BMC MINERALS (NO.1) LTD.

KUDZ ZE KAYAH PROJECT

RESPONSE #2 TO YESAB EXECUTIVE COMMITTEE ADEQUACY REVIEW OF KZK

November 2017

**FIGURE 13-5
OLIVE-SIDED FLYCATCHER HABITAT SUITABILITY - REVISED**

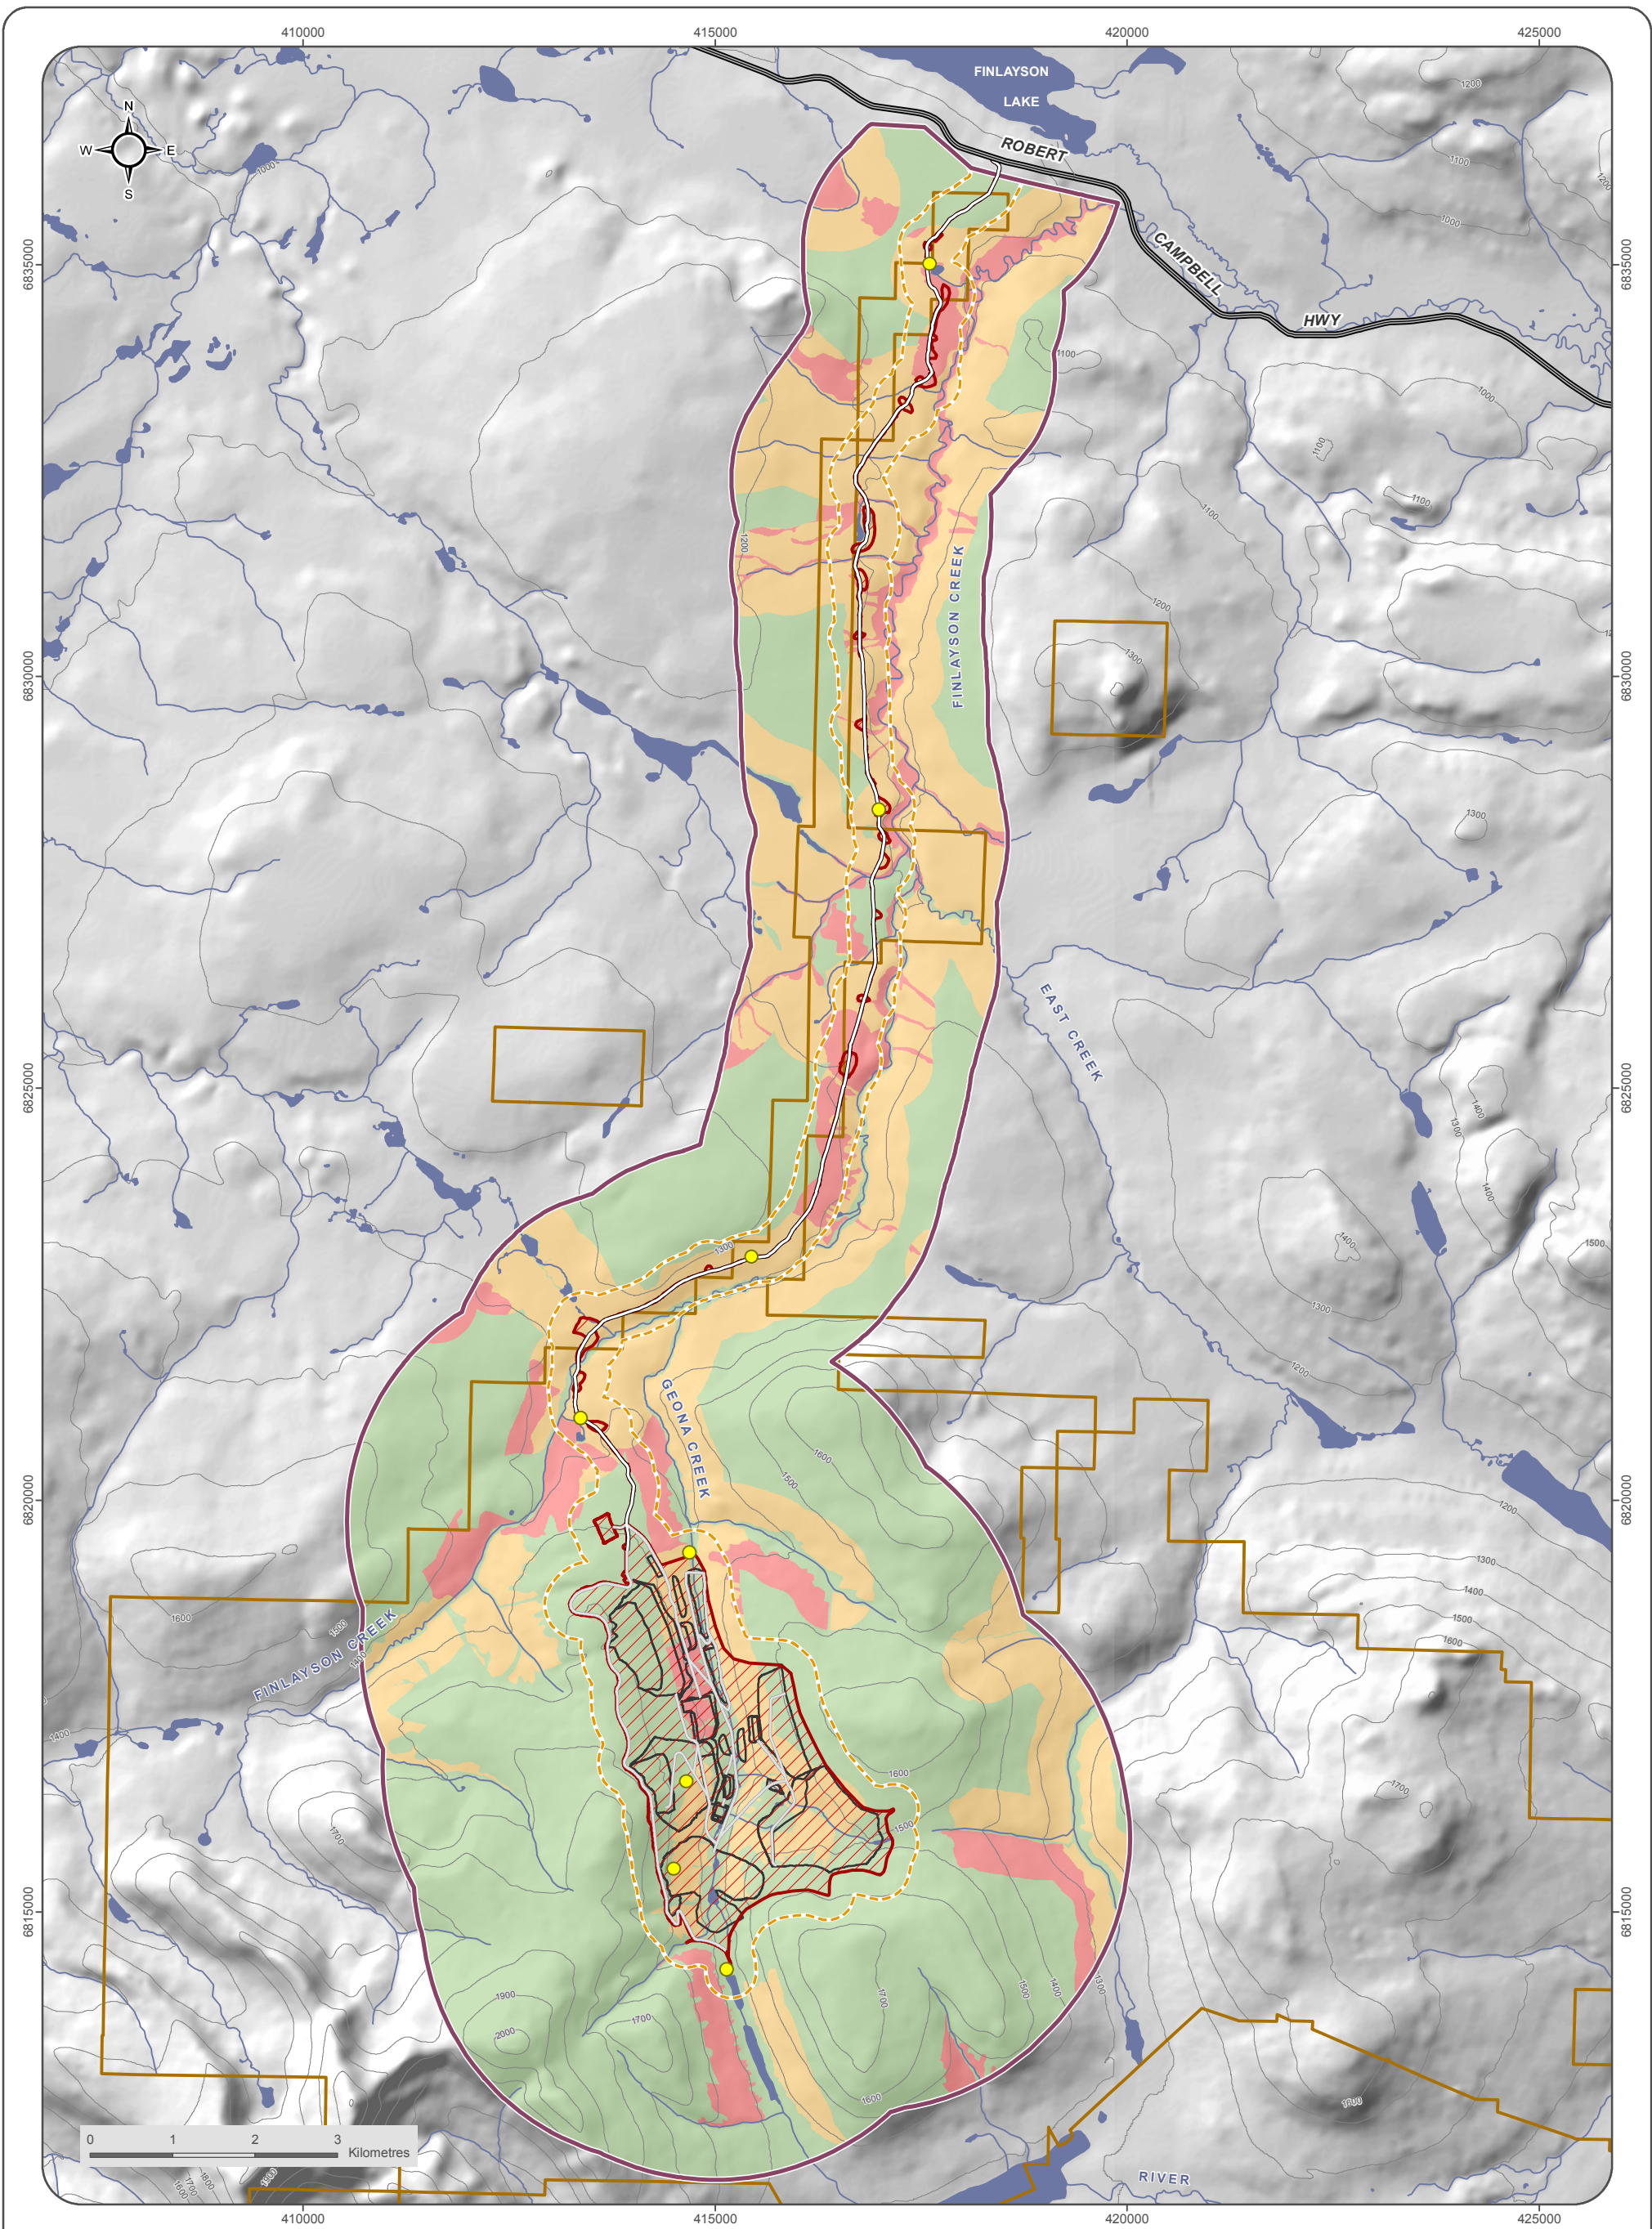
Figure 13-18 identifies habitat suitability for olive-sided flycatcher in addition to olive-sided flycatcher detections. We note that 7 out of 8 detections are within modelled low-value habitat - this does not represent a strong case for the model being able to predict suitable olive-sided flycatcher habitat. Only a single detection appears to occur within high-value habitat. As such, the model appears to do a poor job at quantifying potential olive-sided flycatcher habitat.

Adequate model validation was not provided. It is noted by the proponent that detections were used as a simple validation of the predicted areas of suitable habitat. For olive-sided flycatcher there were 8 detections, one of which was within modelled high suitable habitat. For cliff-nesting raptors (Figure 13-7) there is one detection. For waterfowl (Figure 13-19) there are no detections noted. It is, therefore, unclear how the detections provide any level of validation.

For validation, it is agreed that the point locations for the field observations did not overlay well with the mapped suitability; however, the point locations were approximate since they were from point count surveys and it is uncertain as to how far away the birds were from the observer. This uncertainty should have been described or presented more clearly on Figure 13-2 of the Initial Response Report (BMC, 2017). There are limitations and uncertainty in interpretation of the terrestrial ecosystem mapping to suitable habitat. Structural stage was used; however, there can be sparse trees that are suitable for perching by olive-sided flycatcher in stands where there are some mature trees but the structural stage is not mature forest. These adjustments were made in the revised criteria shown in Table 13-10 and in the revised habitat suitability map in Figure 13-5 (below). Note that the observation points now fall within or very near to moderate and high suitability habitat. Statistical analysis was not completed to validate the model because there are too few observations to make it meaningful on a statistical basis.

**FIGURE 13-15
FINLAYSON CARIBOU HERD
POST-CALVING OBSERVATIONS
2015-2016**

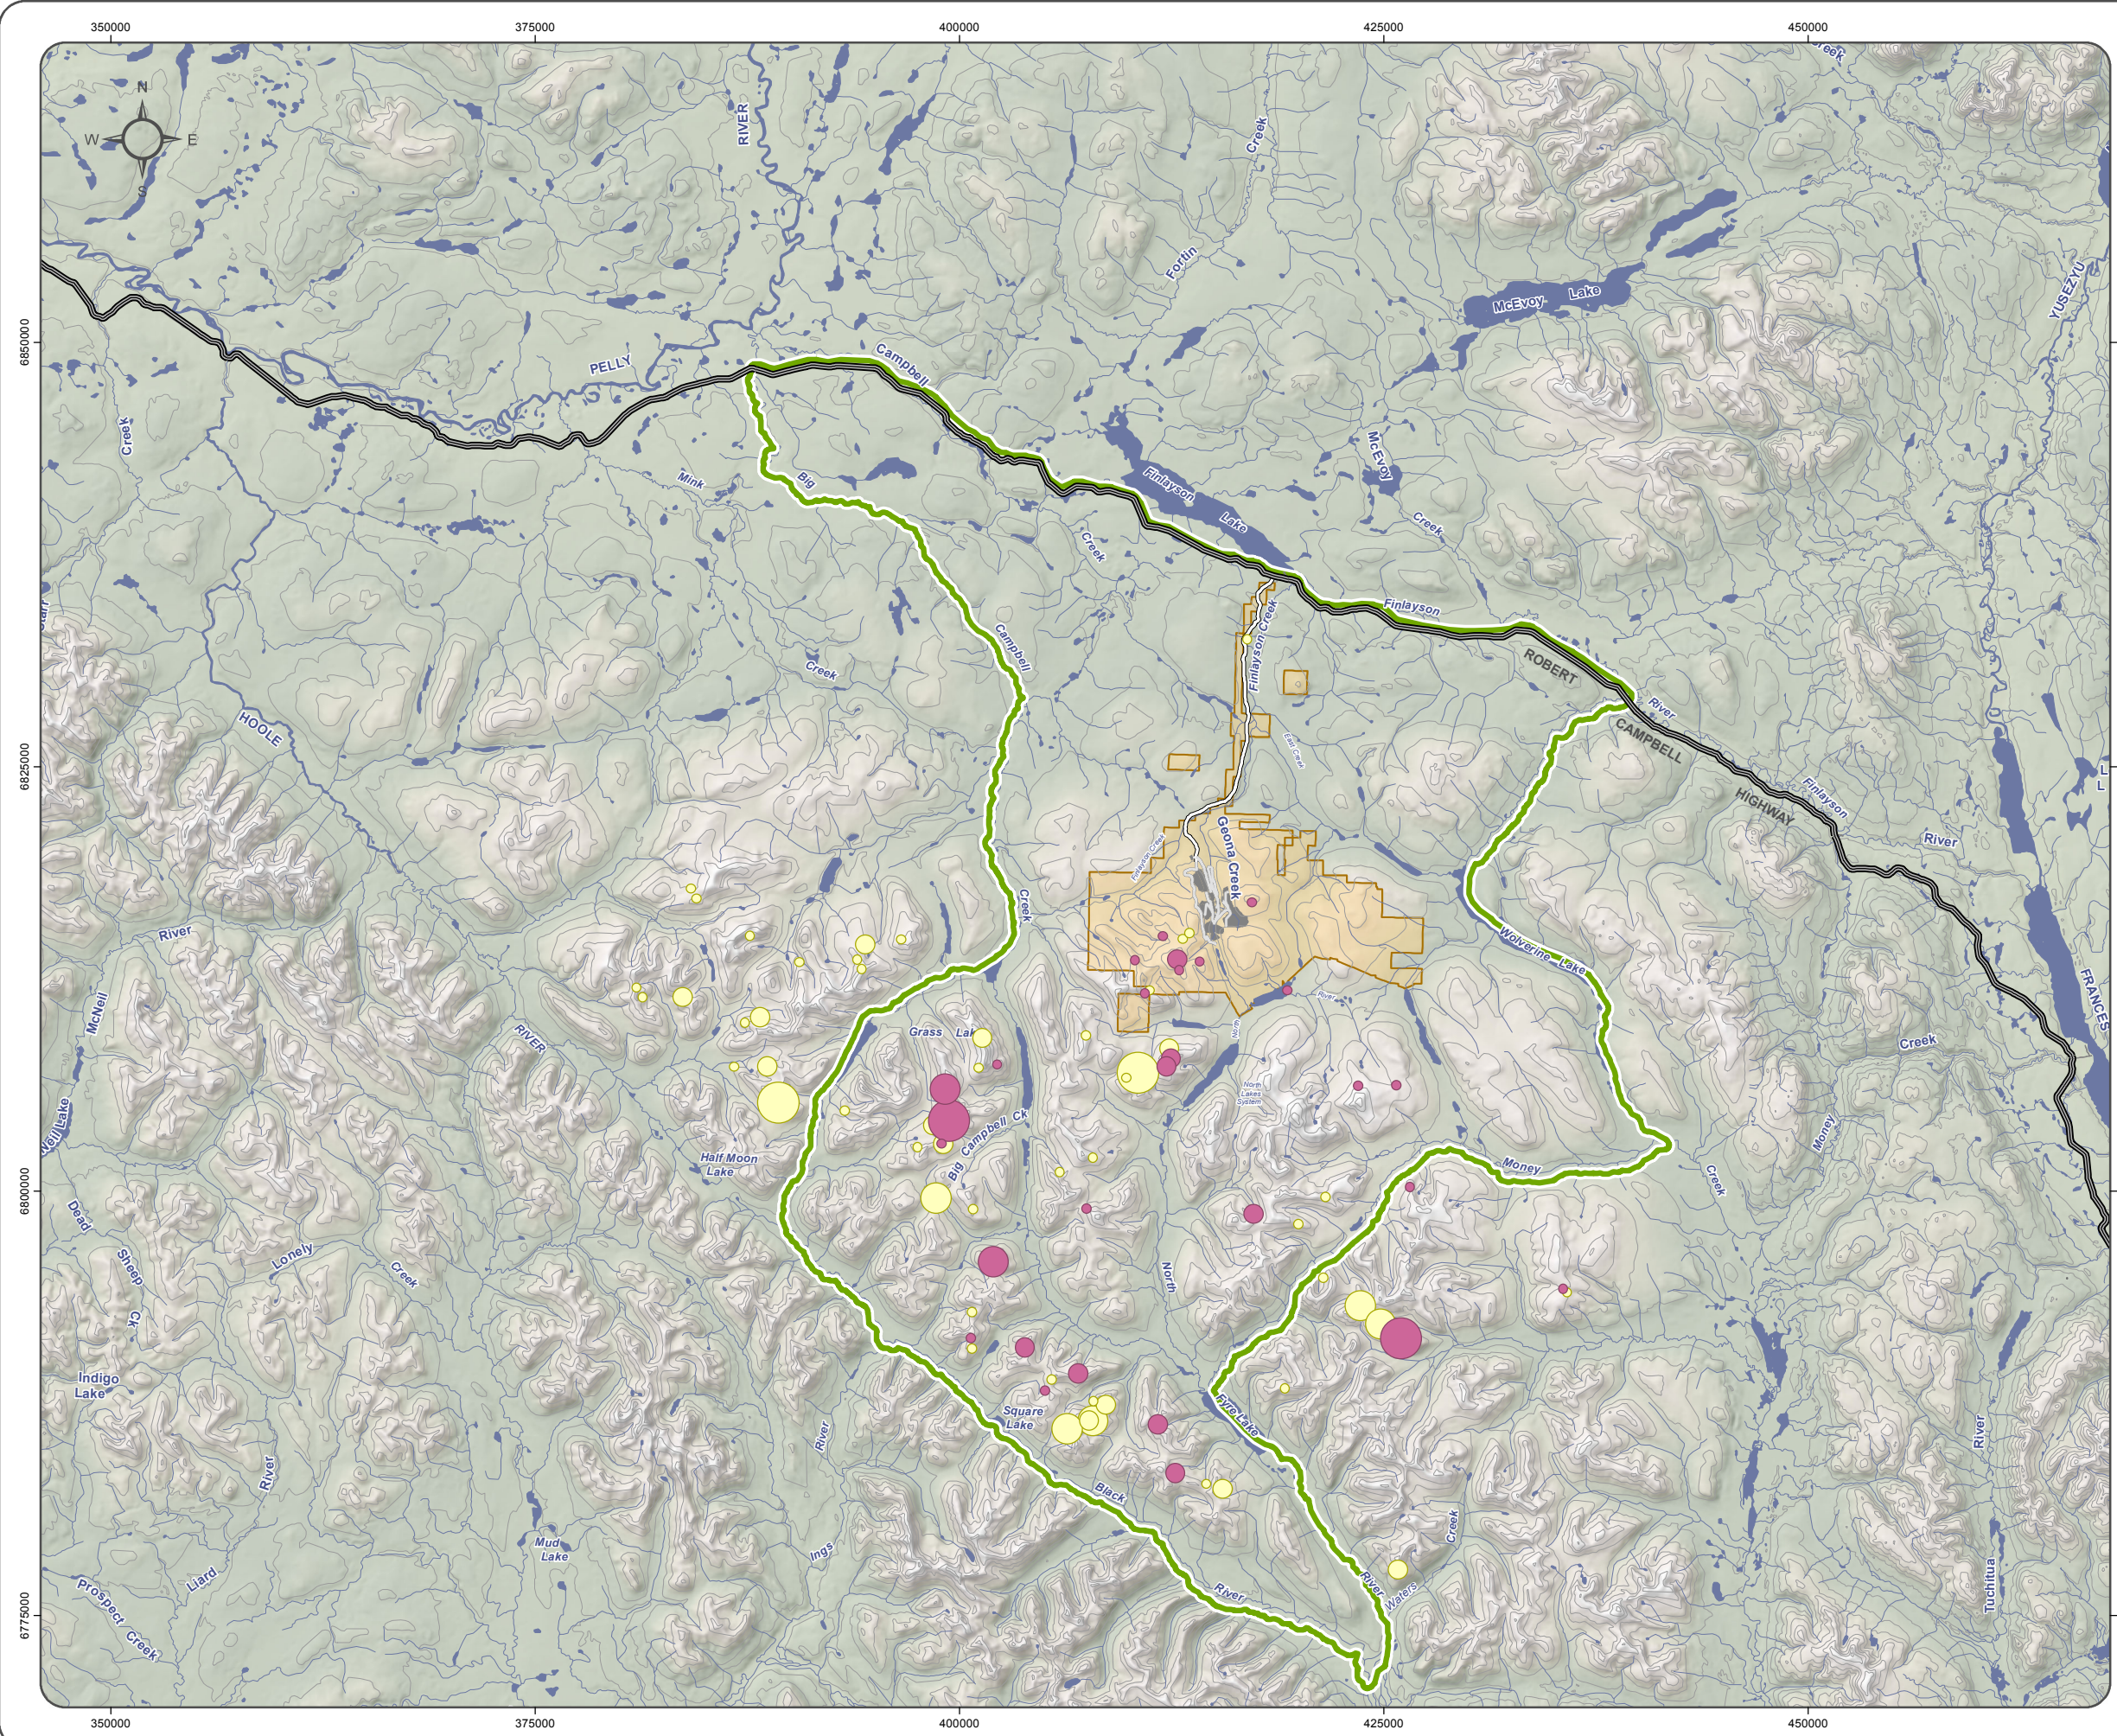
c. Improvement in post-calving information: Display locations for 2015 and 2016 in different colours on Figure 3-8 and comment on consistency in area use between the two years.

Figure 13-15 presents the corrected figure for Finlayson Caribou Herd, Post-calving Observations 2015-2016, from the Wildlife Baseline Report, Appendix E-8 of the Project Proposal and includes the 2016 observations in a different colour. Post-calving observations were distributed throughout the mountains south of the Project. There were more observations closer to the Project area in 2015 than in 2016 and the 2016 observations extended further to the west than in 2015.
